SERVICE LETTER

RUNNING MODIFICATIONS ON CARBURETORS FOR ROTAX® 2-STROKE UL AIRCRAFT ENGINES

SL-2ST-005

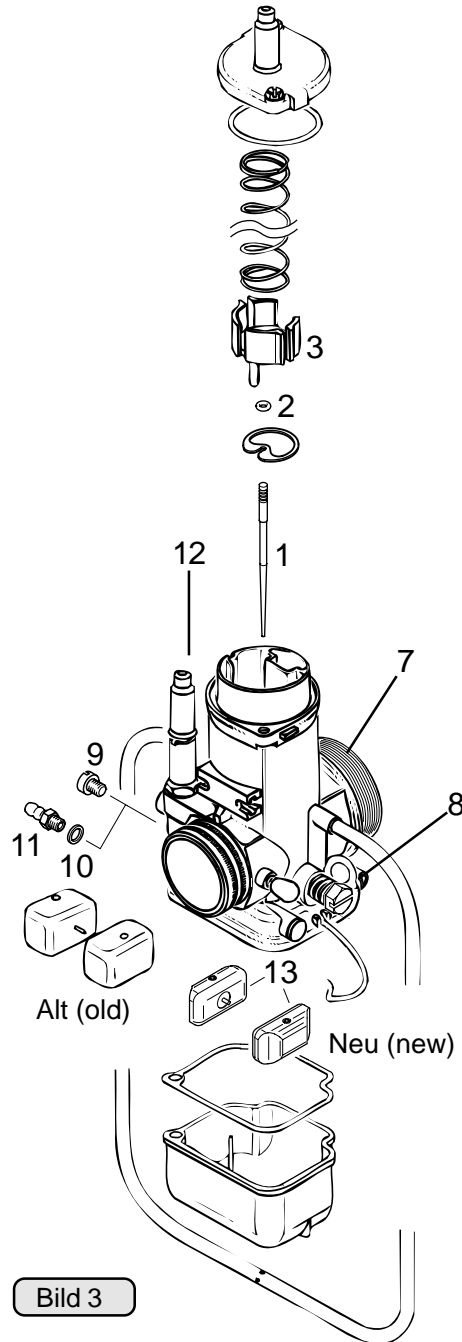
- Damping of jet needle (1) against vibration by additional O-ring (2) 2,5x1,5 (see fig. 1).
- **NOTE:** This O-ring can be installed on older carburetors only if a new spring cup (3) is fitted, as for the additional O-ring a recess (4) in the spring cup is necessary.
- Additional bore (6) Ø 2 mm in the cast fin for wire securing.

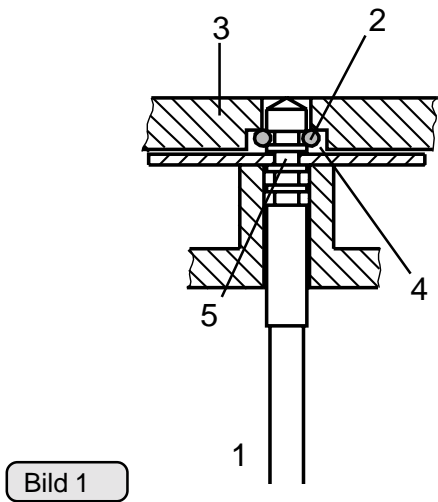
- The suction side carburetor flange (7) is furnished with a thread groove to increase the hold of the intake system (airfilter, intake silencer etc.). See fig. 3.
- The idle air regulating screw (8) is provided with a hexagon head (wrench 13 mm) instead of knurled head. See fig. 3.

- All new carburetors have a depression connection for the high altitude kit (HAC kit). See fig. 3.

◆ **NOTE:** Normally this connection is plugged with a screw (9) M6x5. If the HAC kit is to be connected, this screw is replaced by the sealing ring (10) and hose nipple (11).
